# HumeLink Alliance Inc. - Submission on the stage 1 contingent project application for the HumeLink project, May 30, 2022

HumeLink Alliance Inc. submits the following concerns to the Australian Energy Regulator (AER) on [TransGrid's Contingent Project Application for HumeLink Stage 1 \(Early Works\), 5 April 2022](#).

Figure 1: Source - CIGRÉ as referenced by HDR <https://www.hdrinc.com/insights/top-5-reasons-use-underground-transmission-lines>

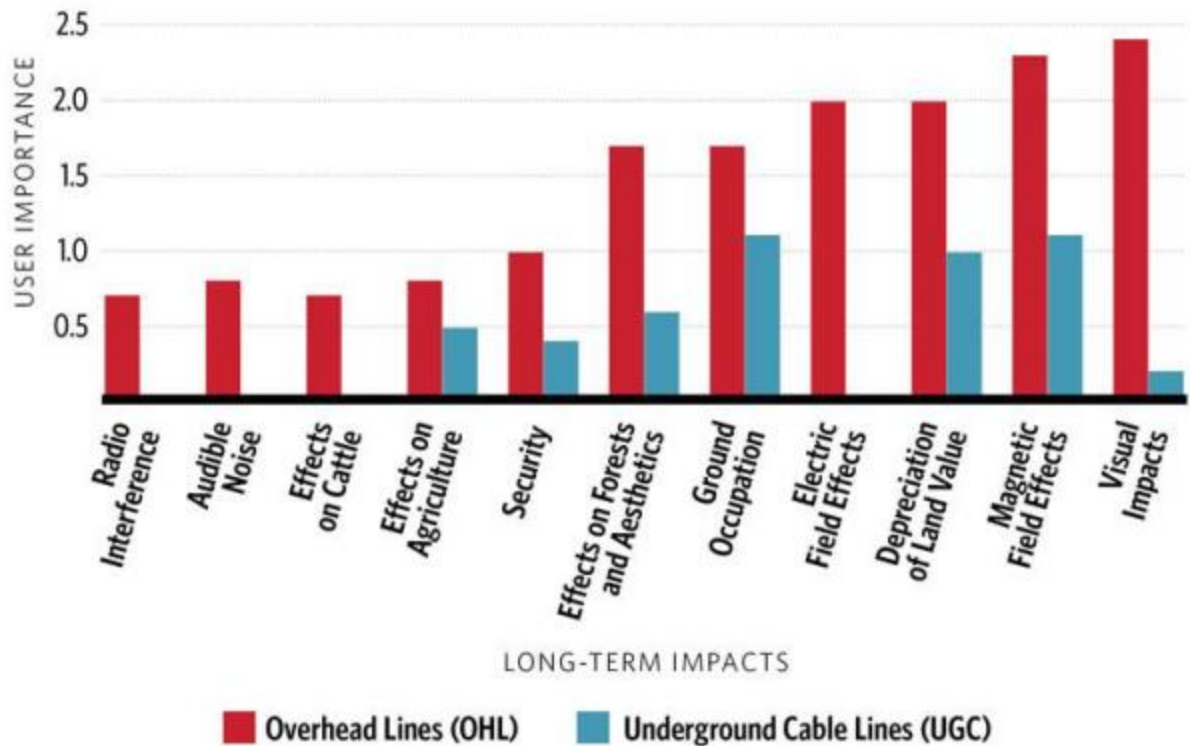
A study by the International Council on Large Electrical Systems, or CIGRÉ, shows the relative environmental impact of overhead and underground lines. In all cases undergrounding reduces impacts (see Figure 1 below).

The biggest impact of concern with overhead transmission lines, identified in the study, is visual impacts.

This InDeGo method purports to assess the 'enviro-social impact' and yet it omits visual impacts, the most important impact of concern for communities, as identified by the overseas study. As a consequence of this analysis the now preferred route will have HumeLink running along a ridge above the township of Tumut, with the locals saying instead of Snowy Valleys, the region will now be known as Ugly Valleys.
